DEVIATION REQUEST AND DECISION FORM

PROJECT INFORMATION – NEW LOG ROAD DEVIATION REQUEST

Project Name : Ellicott Town Center Filing No. 1

SHEET:
PP1

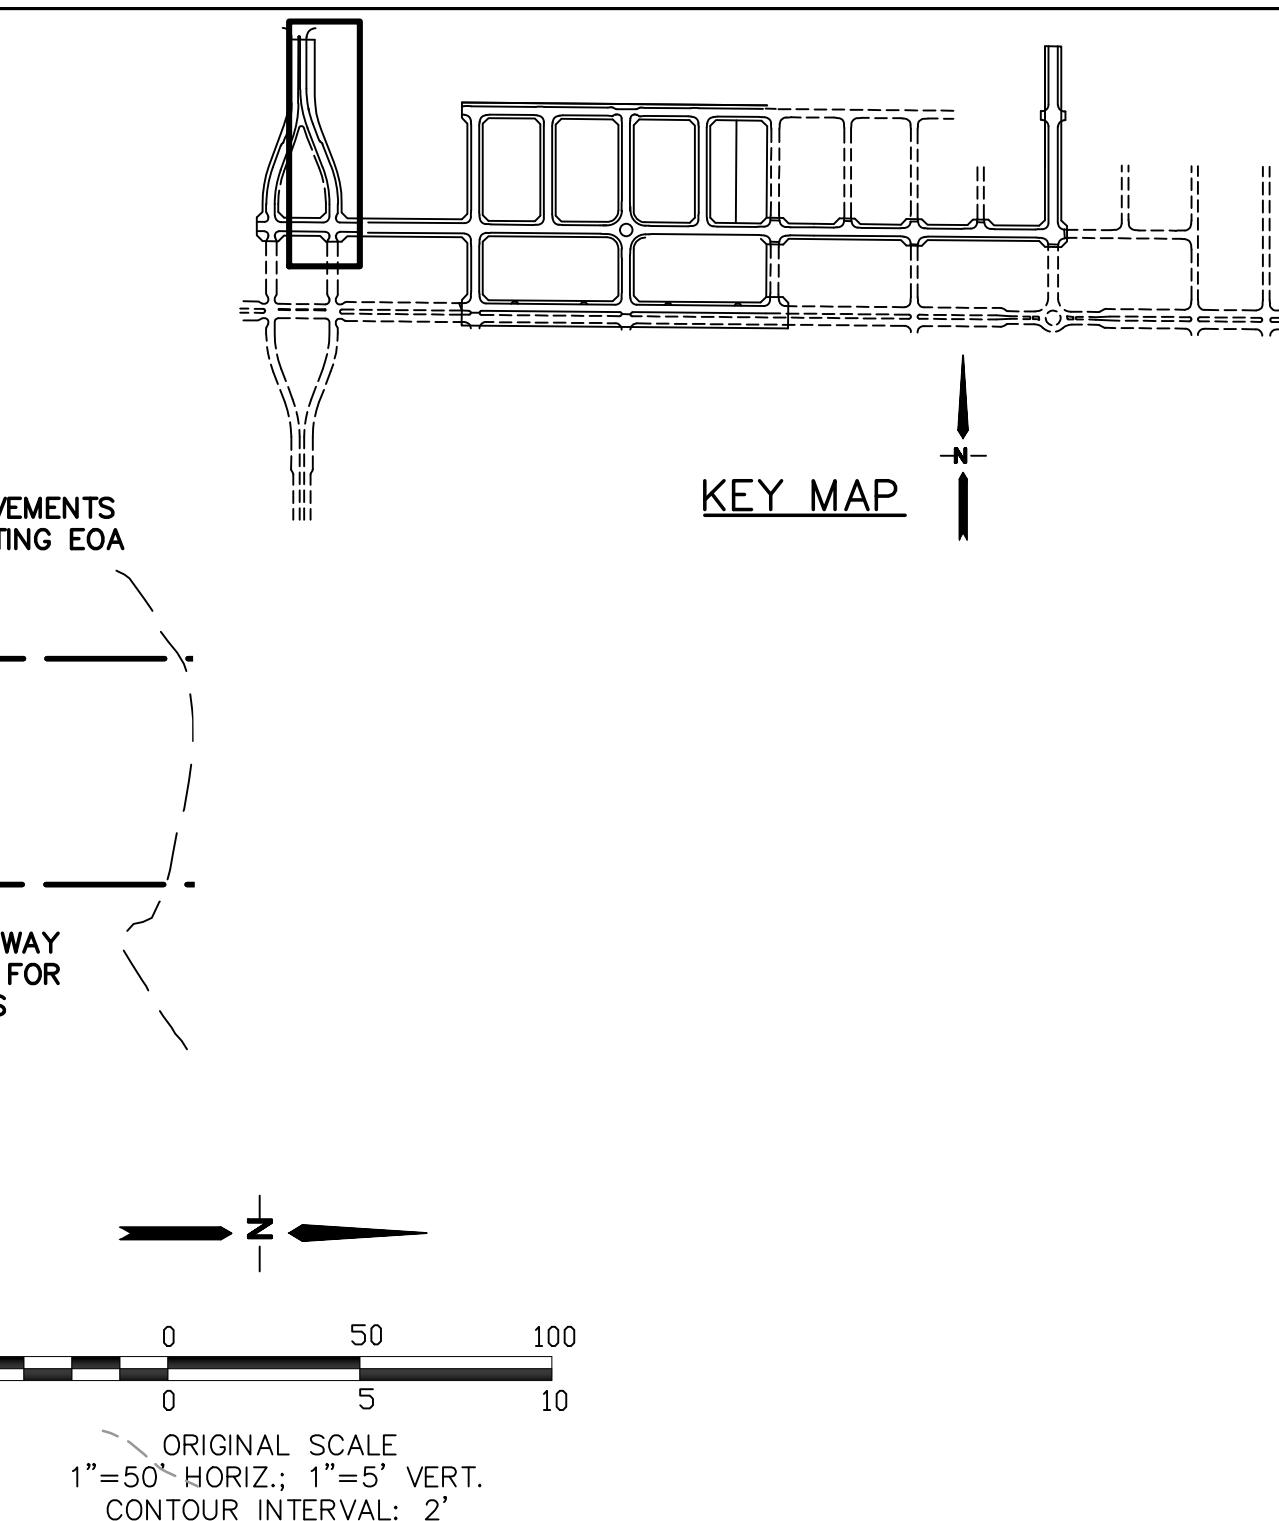
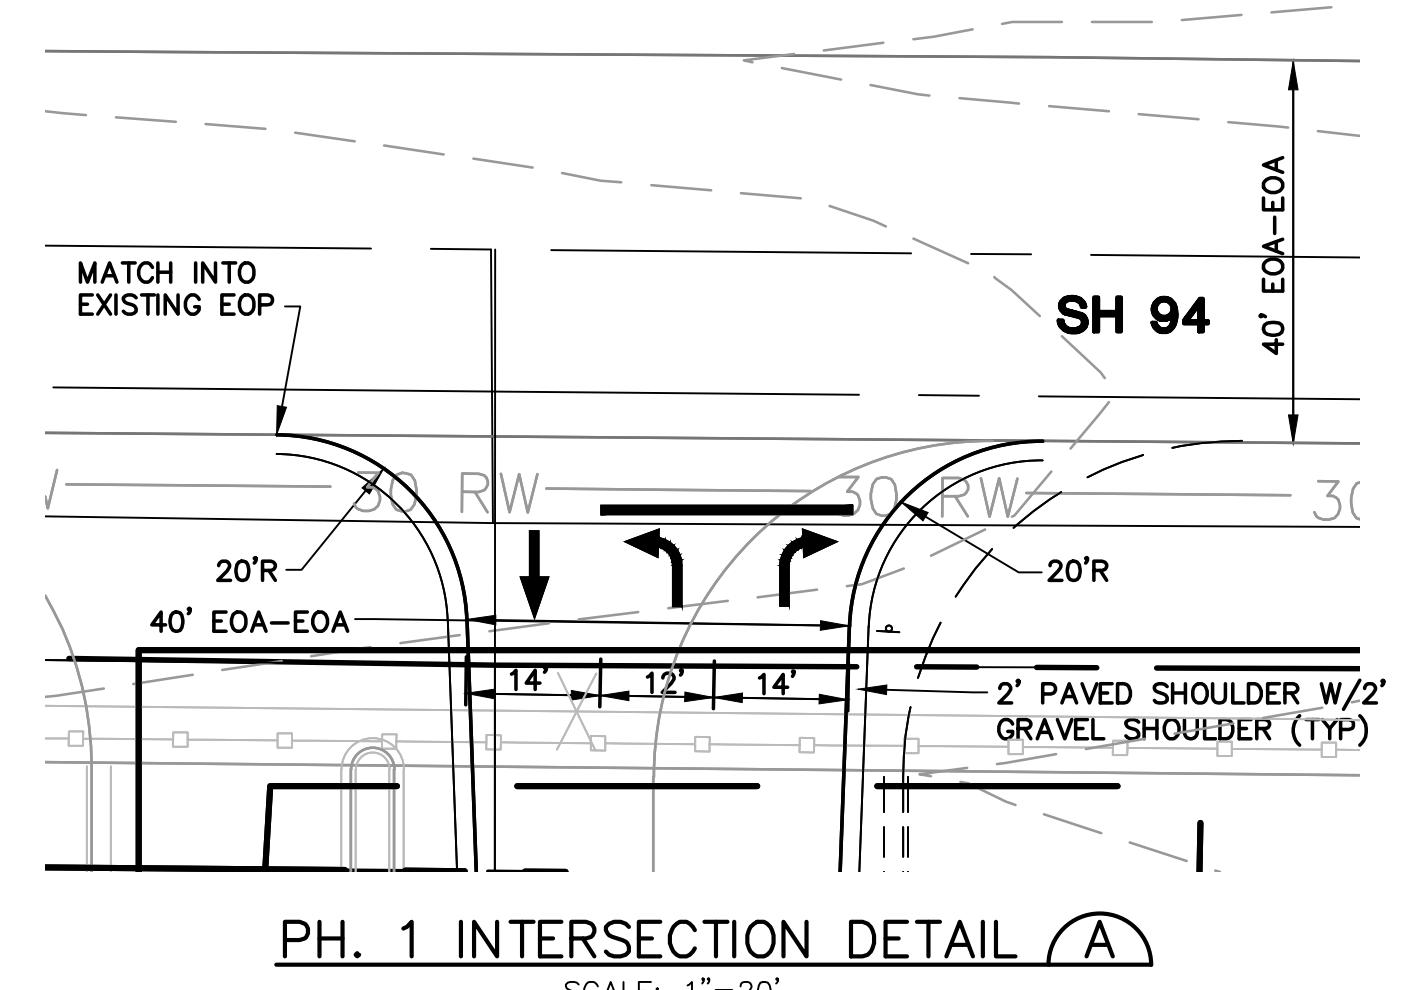
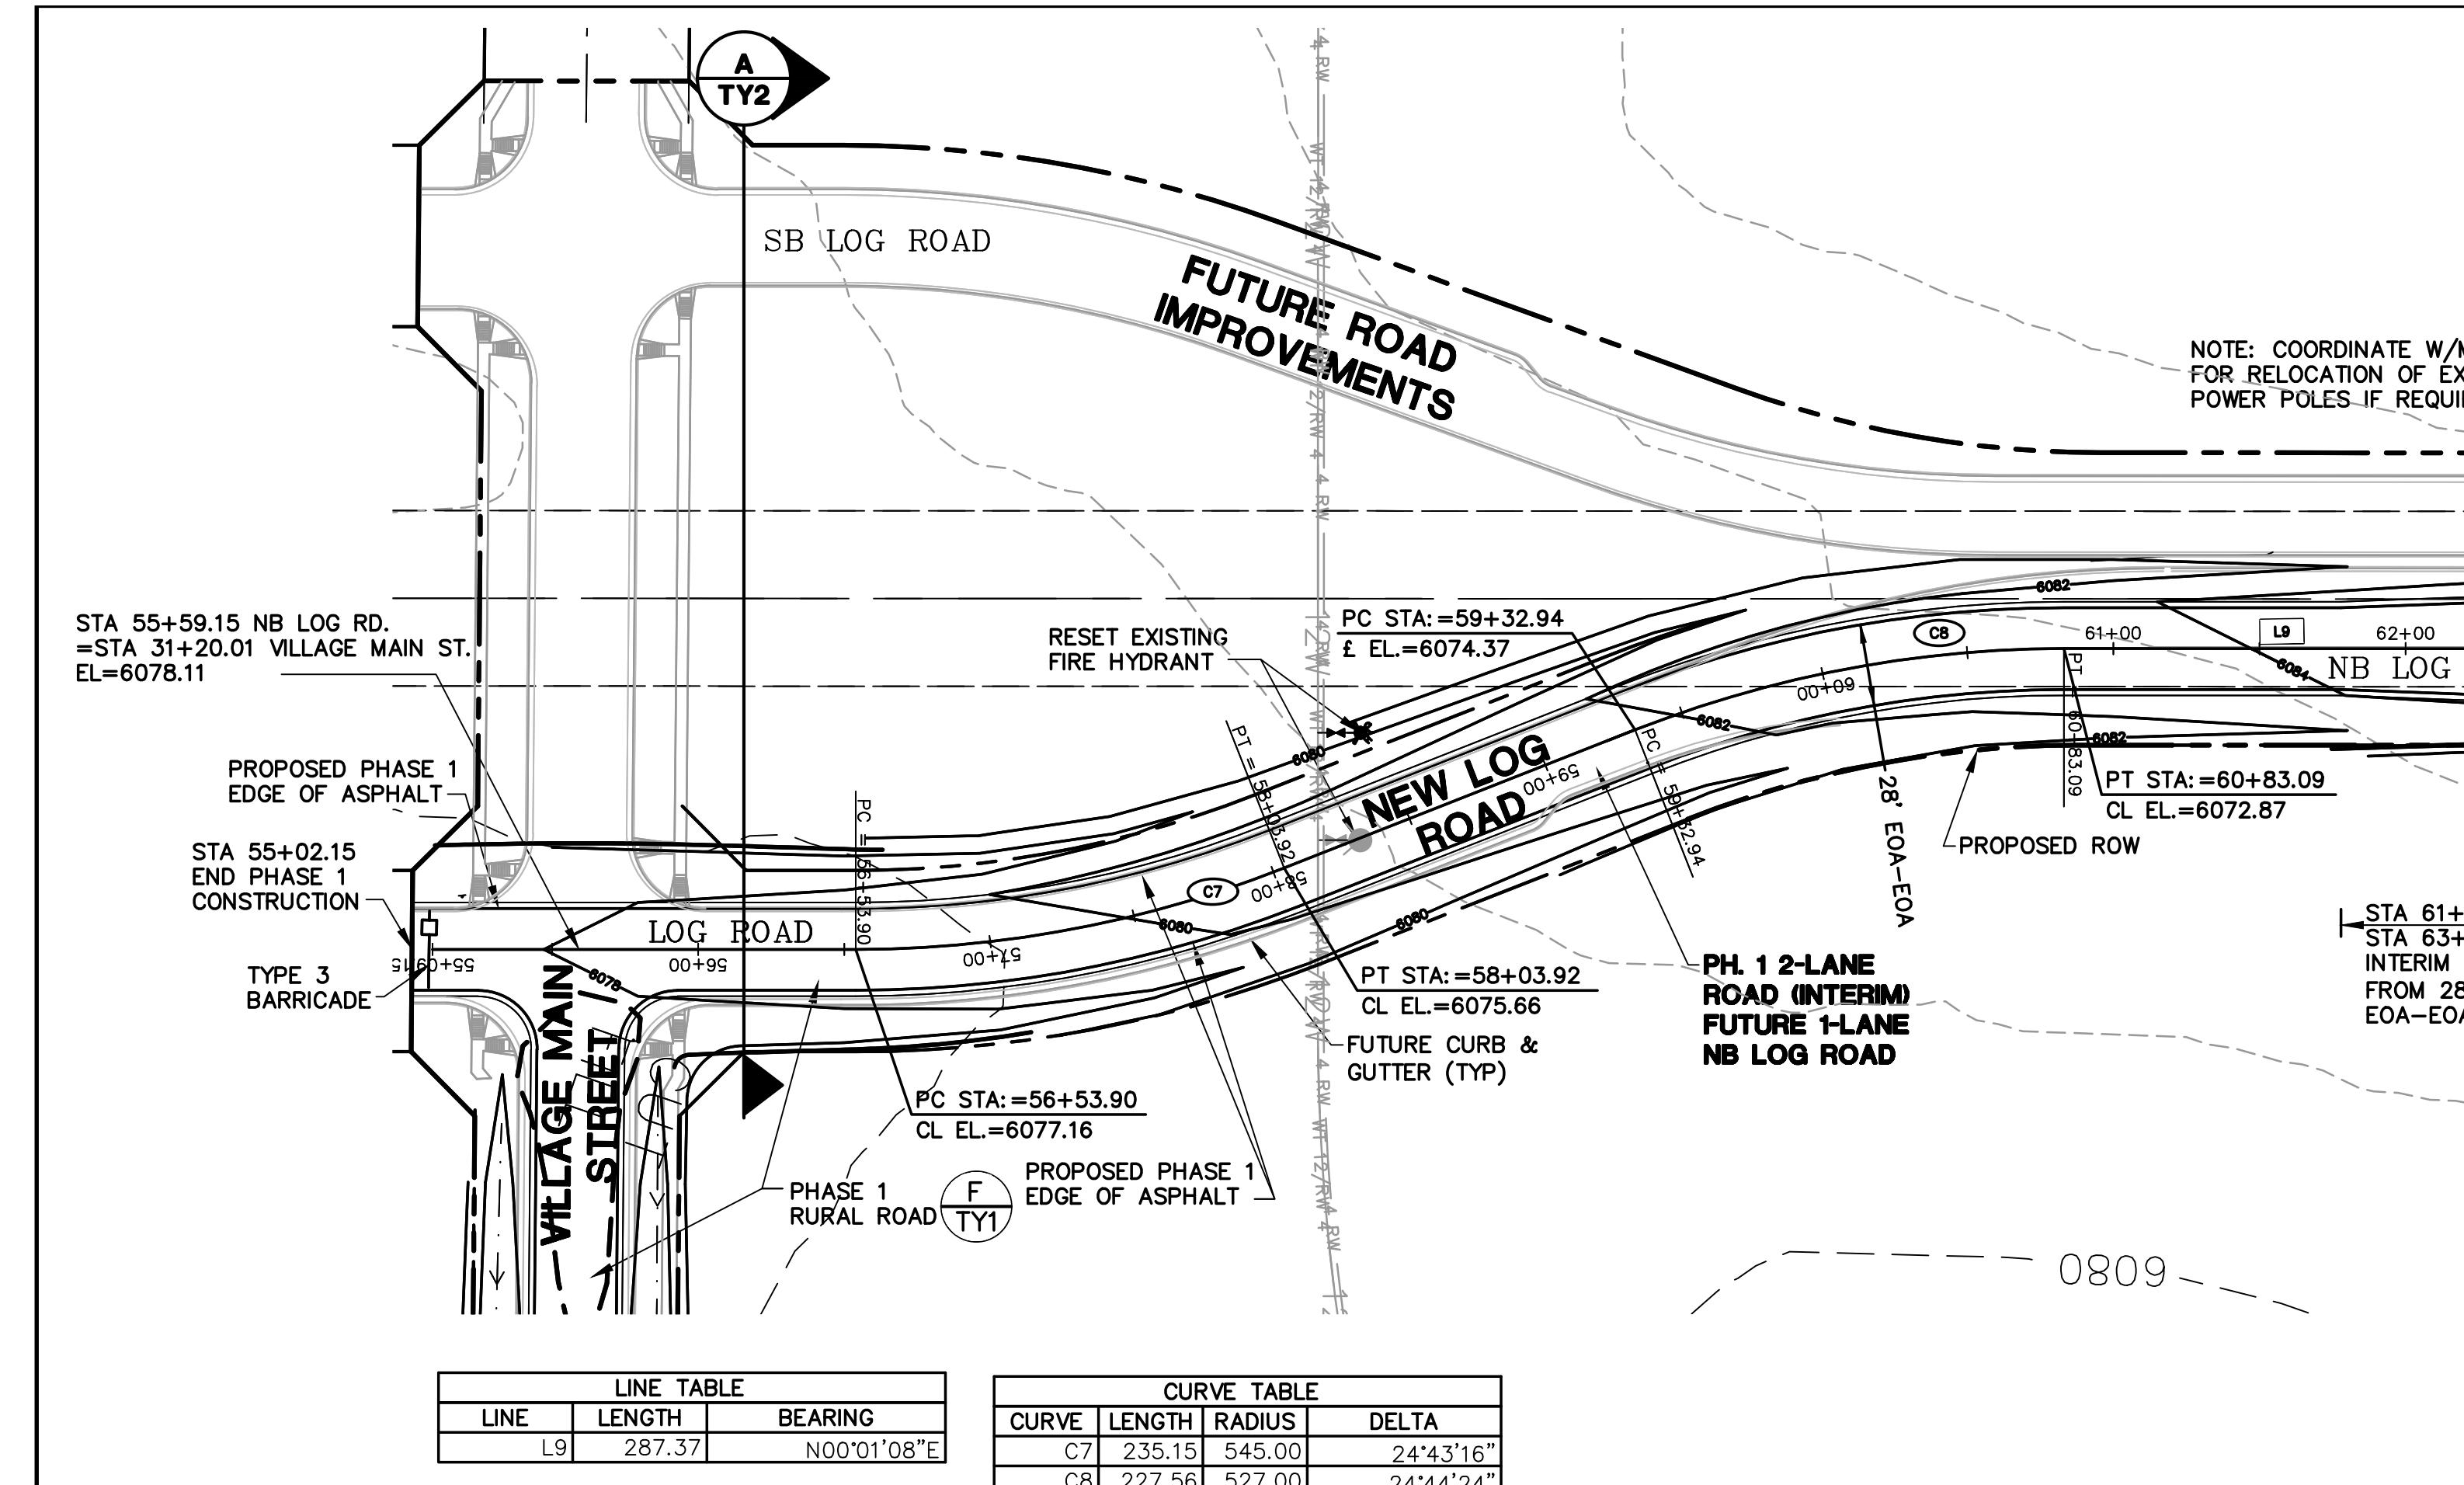
The ECM-prescribed minimum horizontal centerline radius for an urban minor arterial is 565 feet. This deviation request also allows for a slightly reduced minimum centerline radius of 527 feet at couplet transitions as depicted on the attached Plan & Profile Drawing (Sh. PP1).

The proposed minimum centerline radius of 527 feet is only a slight reduction compared to the standard minimum radius of 565 feet.
